**CERTIFICATE OF APPROPRIATENESS**

**Property:** 8815 Dover Street, Lot 4, Block 55, Glenbrook Valley Section 9 Subdivision. The property includes a historic 2,404 square foot, one-story wood frame single-family residence and attached garage situated on a 7,150 square foot (65' x 110') interior lot.

**Proposal:** Alteration – Windows.

WINDOW CONDITIONS

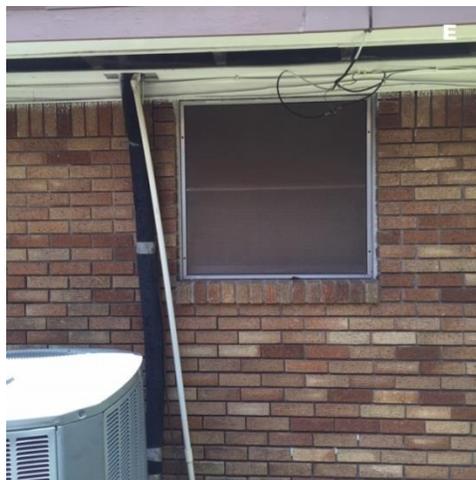
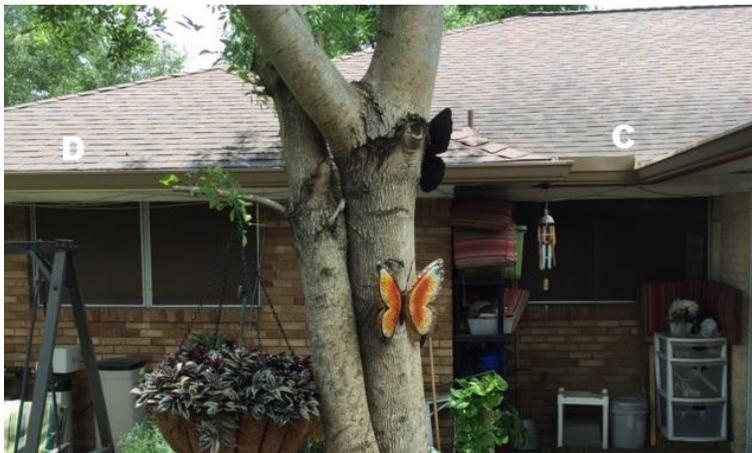
*Window C Interior: Differential settlement has caused separation of the window from the structure. This window is no longer operable.*

*Window C Exterior: Differential settlement has caused separation of the window from the structure. This is evidenced by the gap as well as the displaced brick.*

**Recommendation:** Partial Approval: Approval to replace B,C,D,E,F,G,H,I. Work with staff to find appropriate replacement windows.

WINDOW CONDITIONS

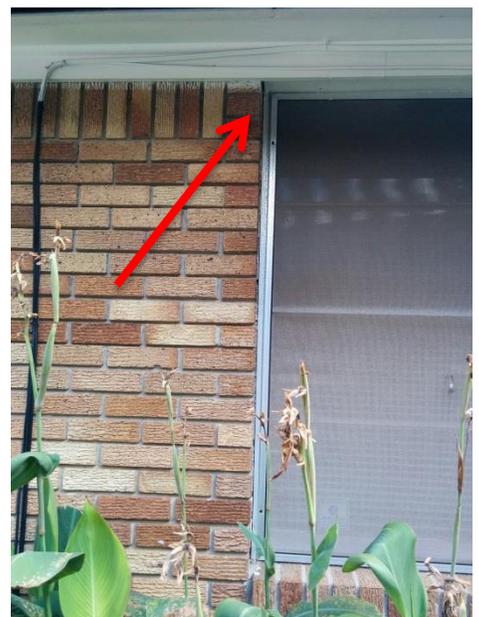
*Window F Exterior: Differential Settlement has caused the separation of the window frame from the building.*

*Window I Exterior: Evidence of foundation failure that has led to the window wacking out of square and being rendered inoperable.*

*Window H Exterior: Differential settlement has caused the window to separate from the structure.*

*Window H Exterior: Differential settlement has caused the window to separate from the structure.*
